UNITED STATES PATENT AND TRADEMARK OFFICE

APPLICATION NO.	FILING DATE	FIRST NAMED INVENTOR	ATTORNEY DOCKET NO.	CONFIRMATION NO.
10/773,059	02/04/2004	Bohumil Lojek	ATM-275	5441
3897	7590	12/27/2005	EXAMINER	
SCHNECK & SCHNECK P.O. BOX 2-E SAN JOSE, CA 95109-0005			SOFOCLEOUS, ALEXANDER	
			ART UNIT	PAPER NUMBER
			2824

Office Action Summary	Application No. 10/773,059	Applicant(s) LOJEK, BOHUMIL	
	Examiner Alexander Sofocleous	Art Unit 2824

3. The drawings are objected to because a few minor discrepancies exist across the Figures and require correction. The following minor discrepancies are noted:

OLD

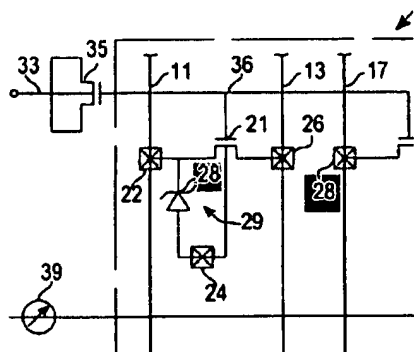
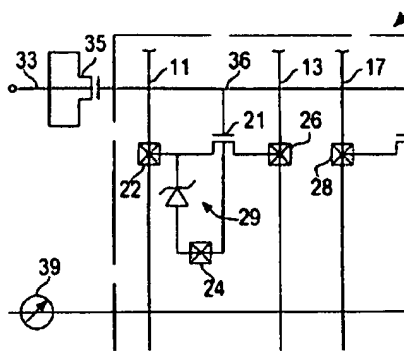
Fig.1 shows two components labeled 28 (the anode of diode 29; the contact on bit line 17). It appears that Applicant intended 28 to be the contact point (see Fig. 1 [connection of bit line 17 to EEPROM 23]; Fig. 2 [connection to EEPROM 23]); Fig. 3 & 4 [isolation region 82 of EEPROM 23; contact 28 of EEPROM 23]). Examiner recommends deleting label 28 pointing to the cathode of the diode on Fig. 1 (see suggested markup on top of next page).

NEW PROPOSED CORRECTION

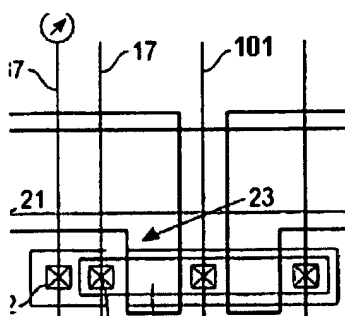
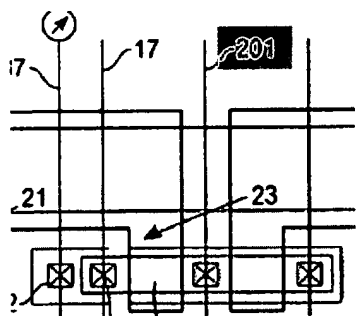
Fig. 4 shows unidentified line 201 (between 23 and 223). The specification indicates, "Shared line 101, a common electrode for memory transistor 23 and 223..." (page 10, line 31). Examiner assumes applicant intended to label said line of Fig. 4 as 101 (see suggested markup below).
